## STAFF REPORT

**AGENDA ITEM:** Final Plat and Planned Unit Development (PUD) Plans and Conditional Use Permit for Day Care Facility to be called Growing Explorers Learning Center

Re: Growing Explorers (Boulder Ponds Outlot A)  
Engineering Site Plan Review

## SITE PLAN

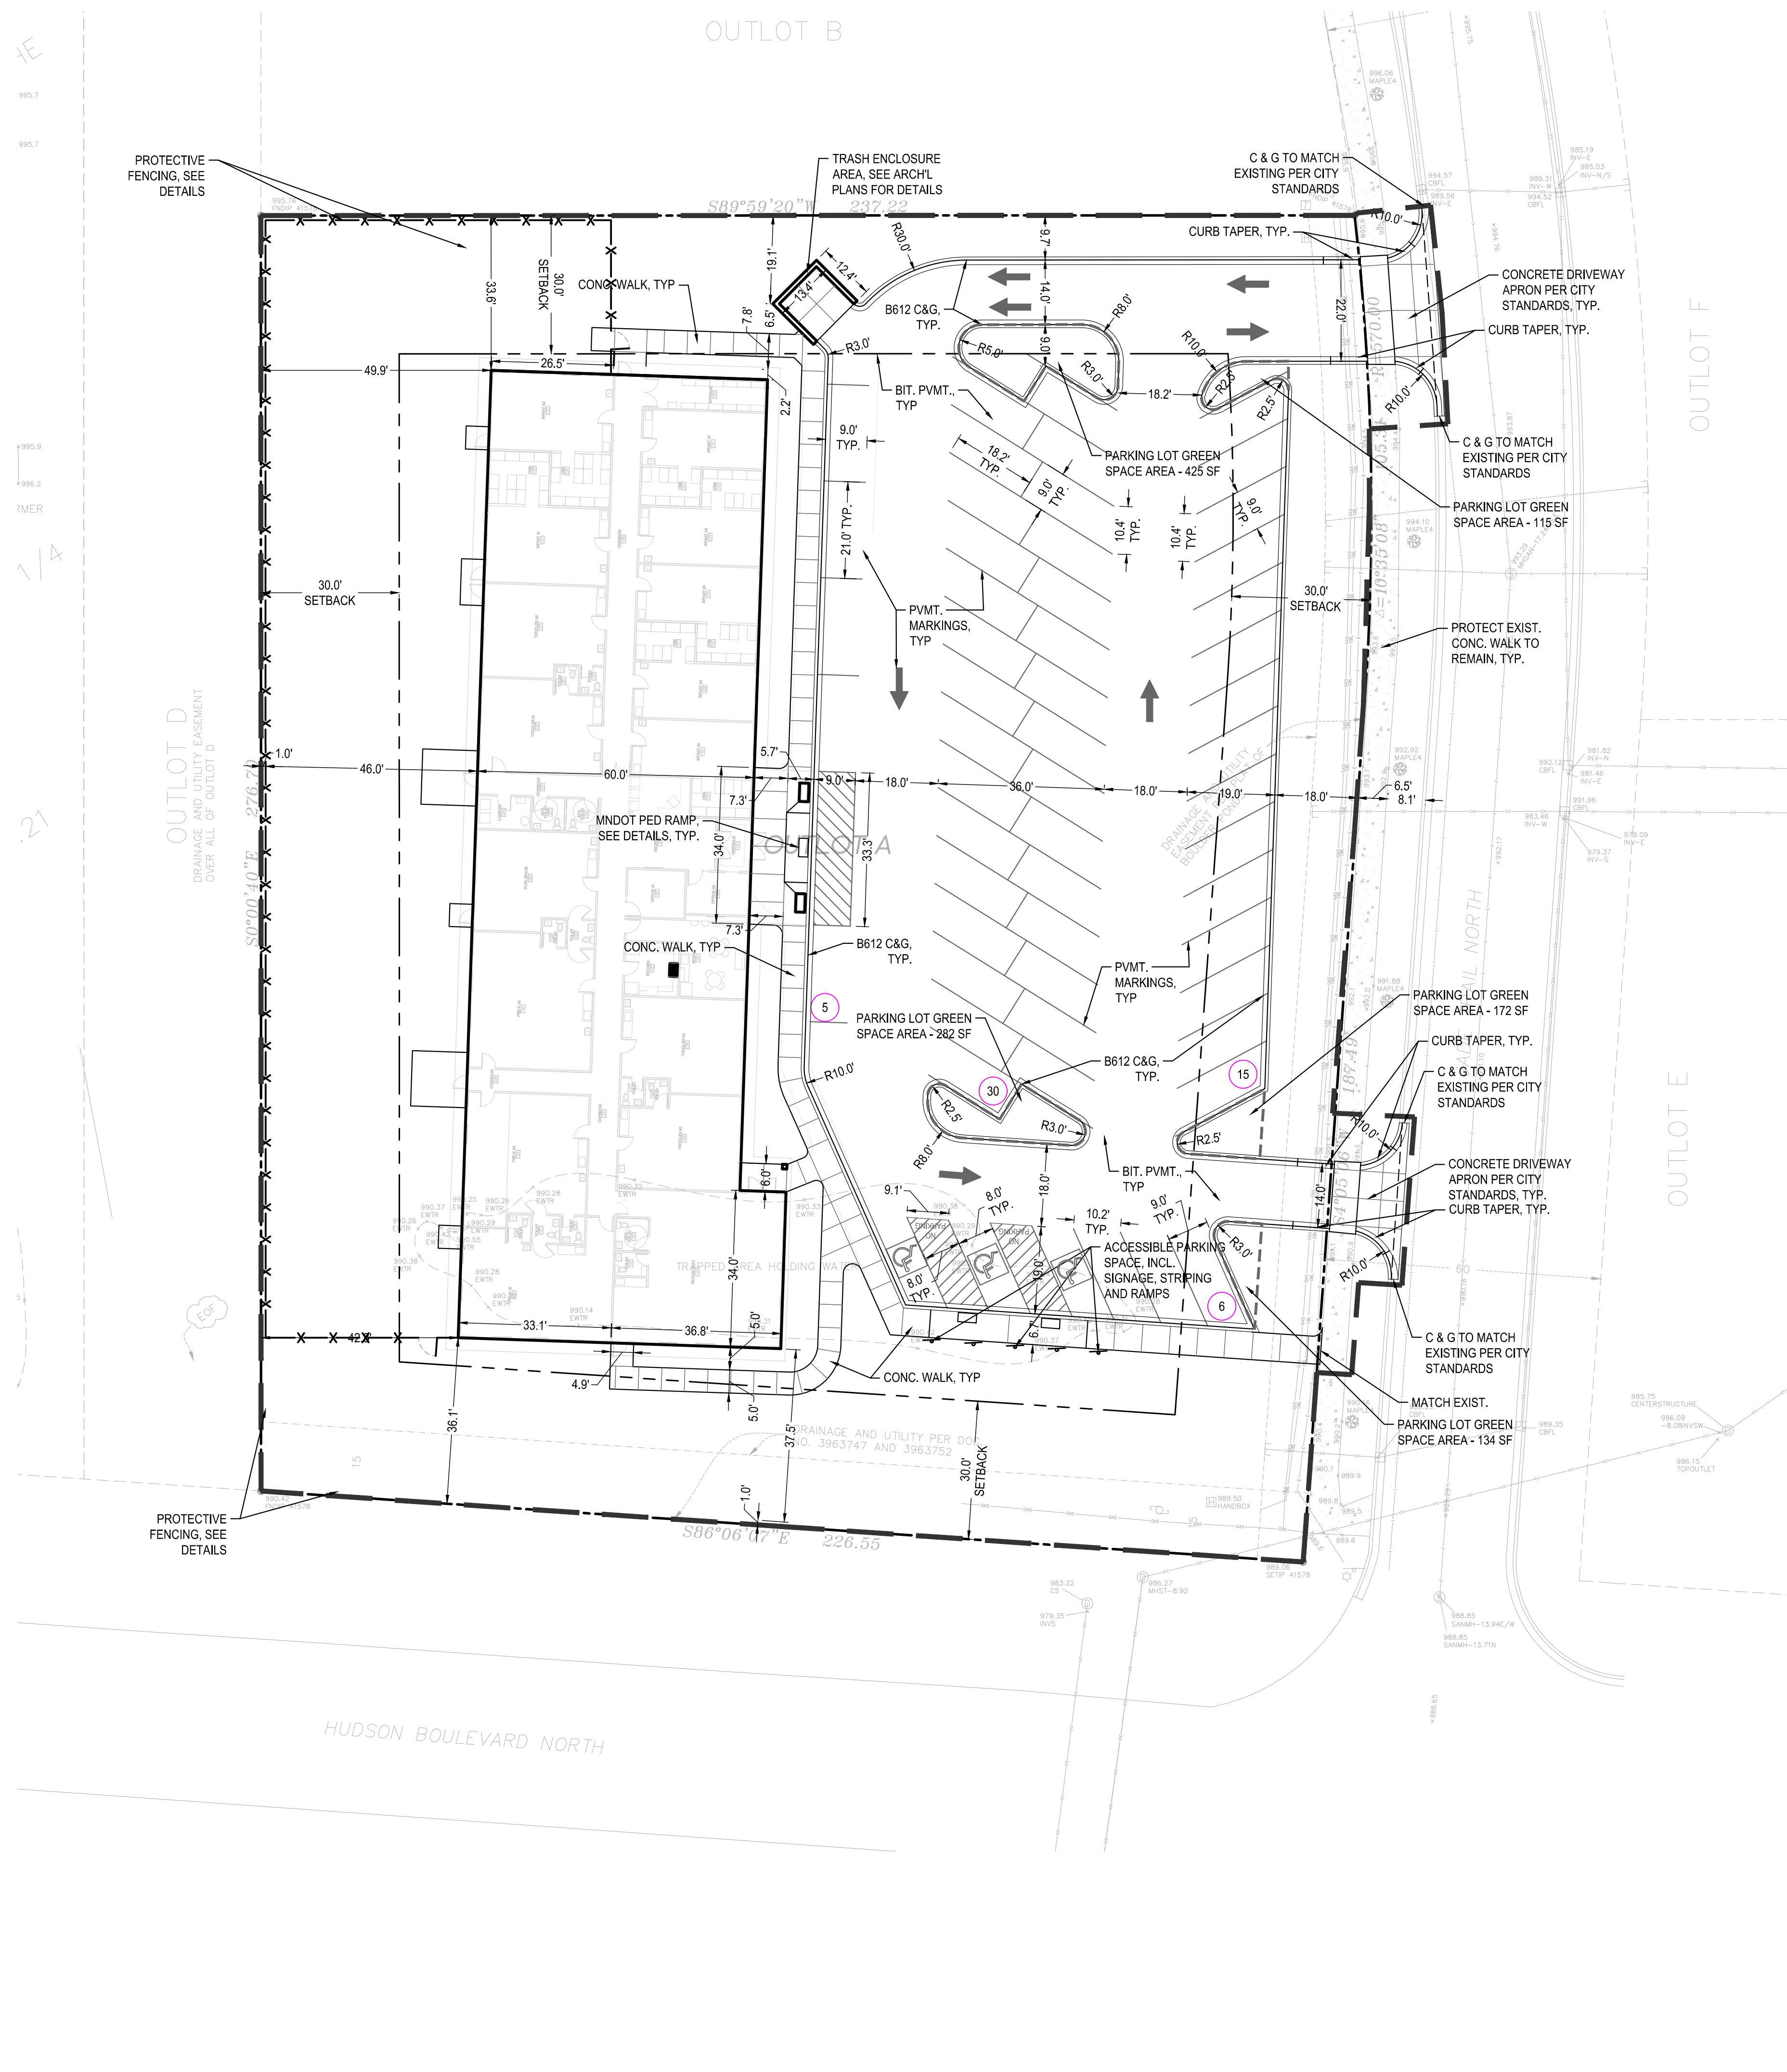
- The proposed access locations appear acceptable.

UTILITY PLAN

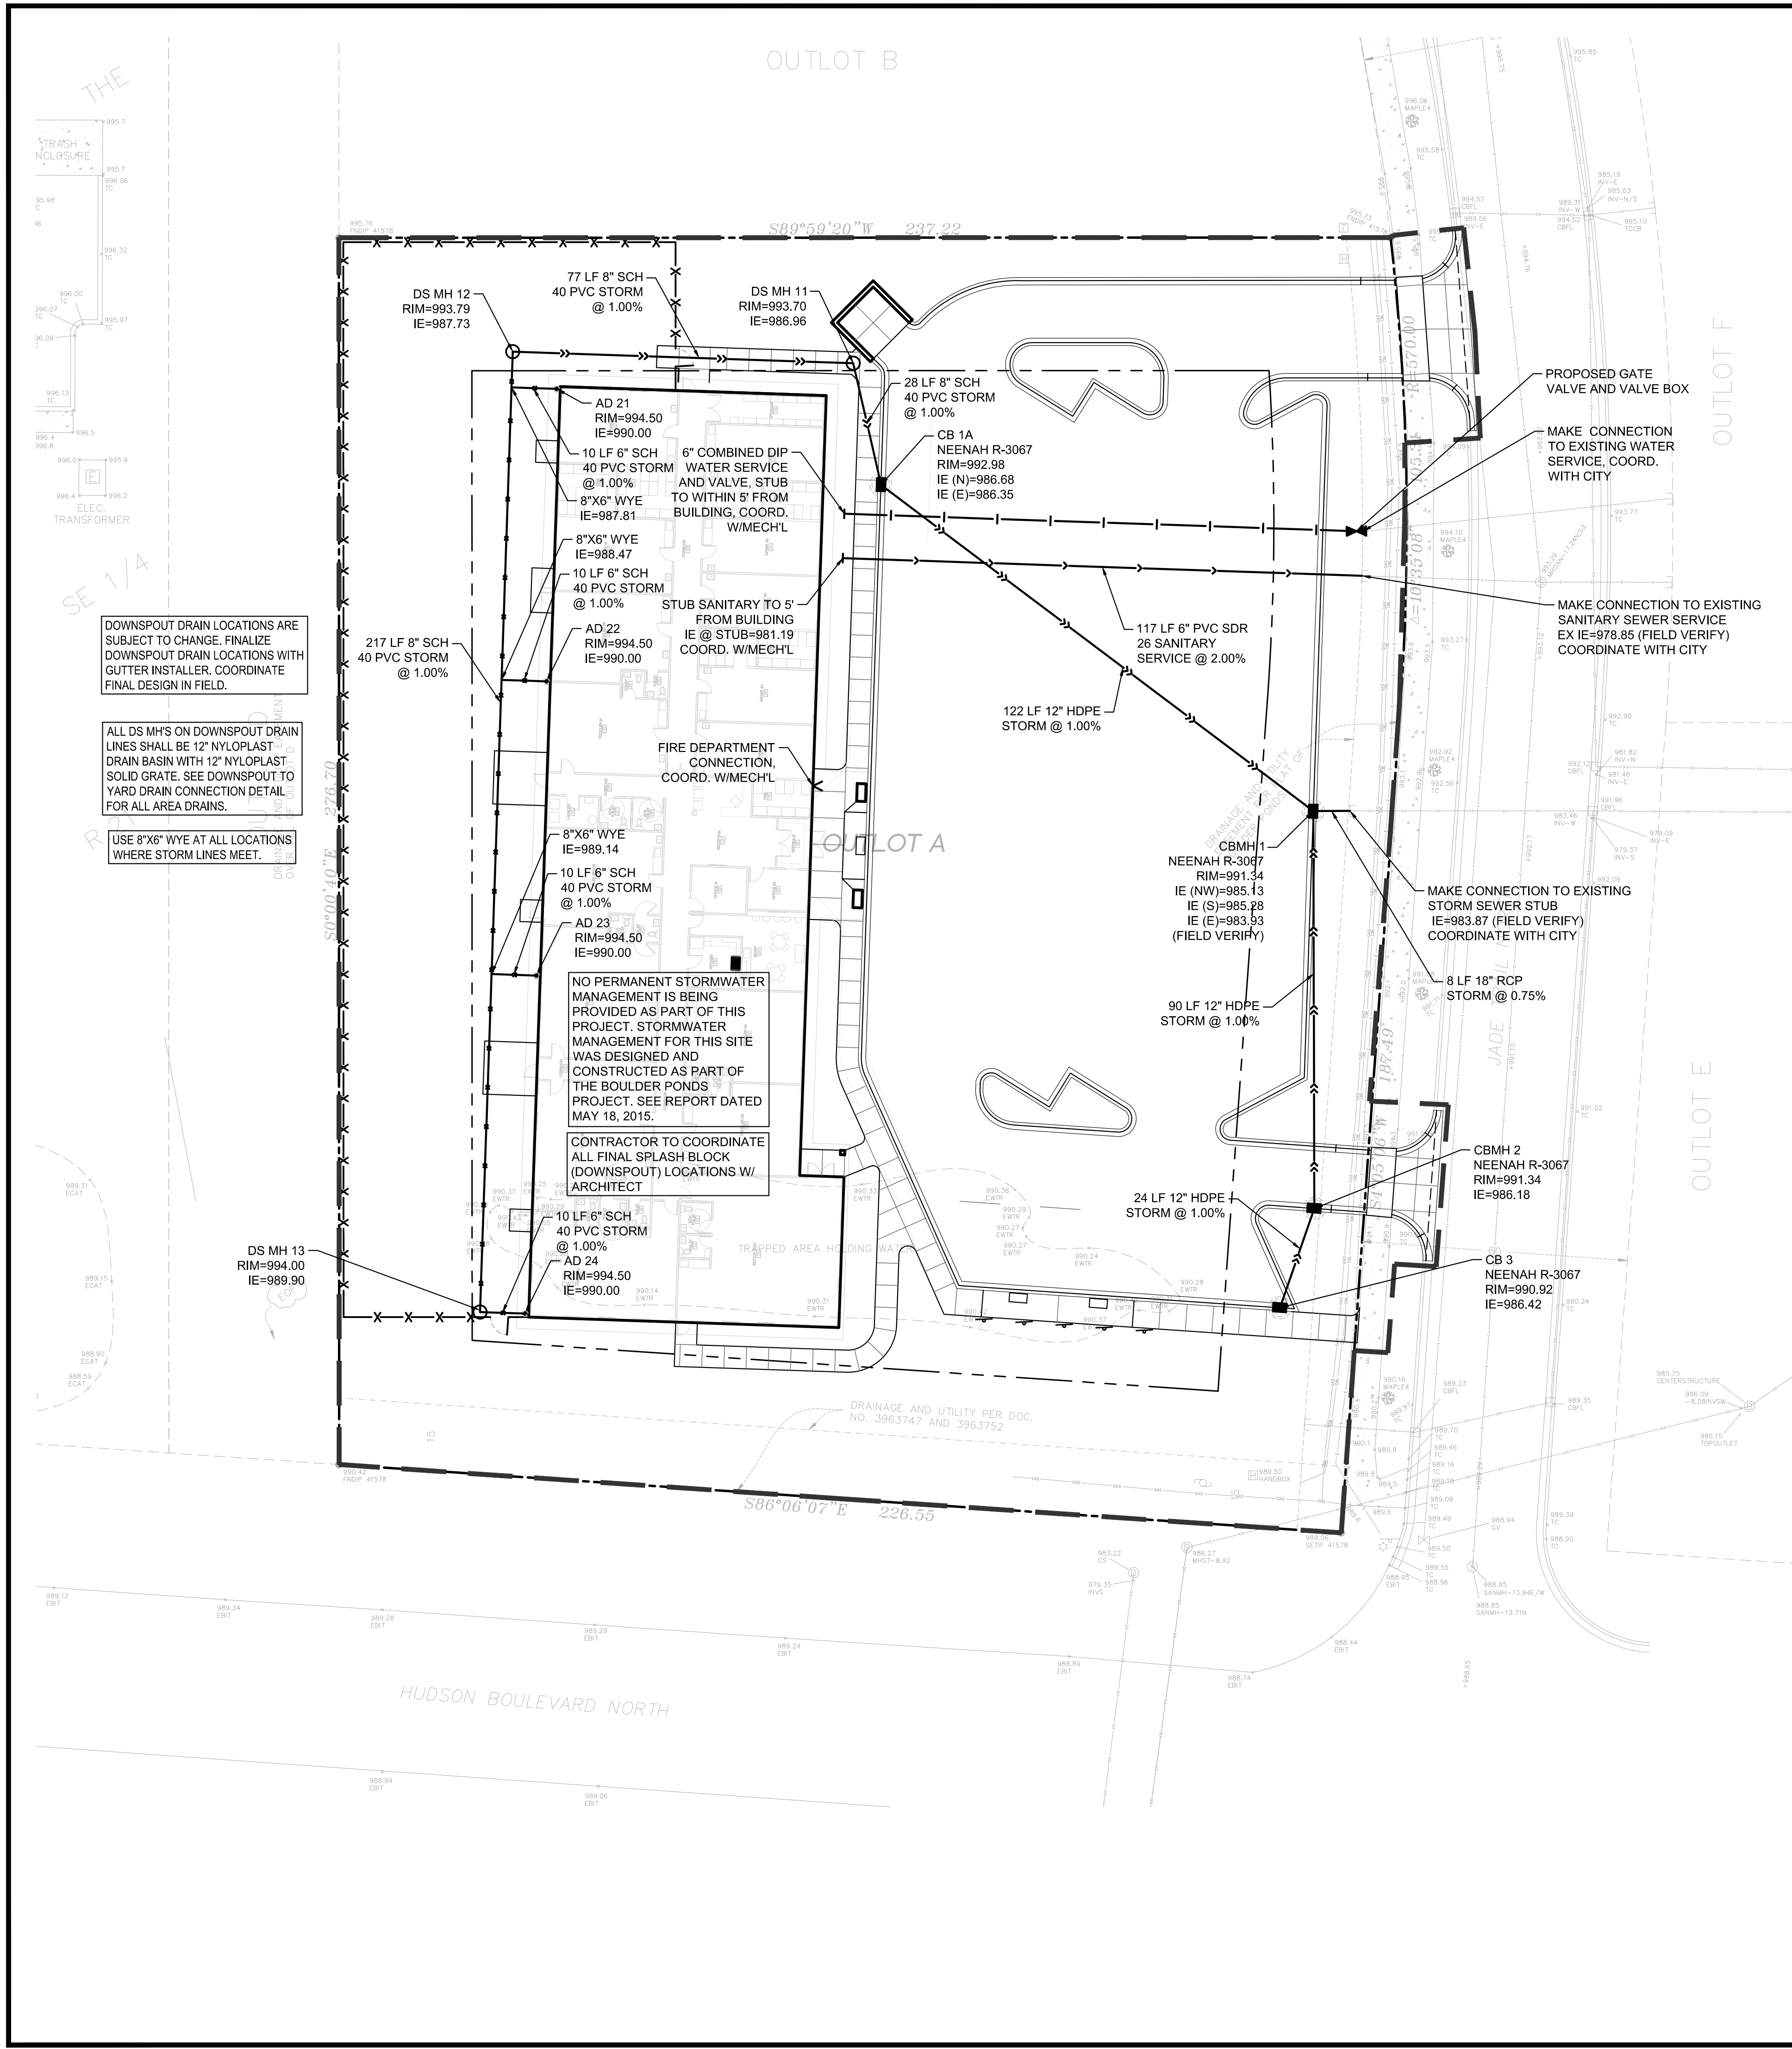
3. C4.0. Add plan note indicating that 100% of the building roof runoff must be captured and conveyed to the storm water basin located on the east side of Jade Trail North. No roof runoff is allowed to drain to the infiltration basin/drainage swale located west of the proposed building on Boulder Ponds Outlot D.

3. C4.0. Identify irrigation service locations, if any, and coordinate landscape plan and utility plan accordingly.
4. Fire Hydrant locations. No new fire hydrants have been proposed. There is one existing fire hydrant located along Jade Trail North approximately 110 feet north of the north Outlot A property line. If fire hydrants are required to be placed interior to the site of Outlot A, the fire hydrants and connecting watermain will be City owned and maintained. If required, the site and utility plans, and project specifications must be revised and resubmitted for City review, showing the proposed hydrants and connection watermain using City design standards, details and specifications. Utility easements must be dedicated to the City, minimum width of 30-feet centered over the pipe and hydrants, and all easements must be shown on the Site Plan, Utility Plan and Grading Plan. City standard plan notes for watermain must be shown on the utility plans.
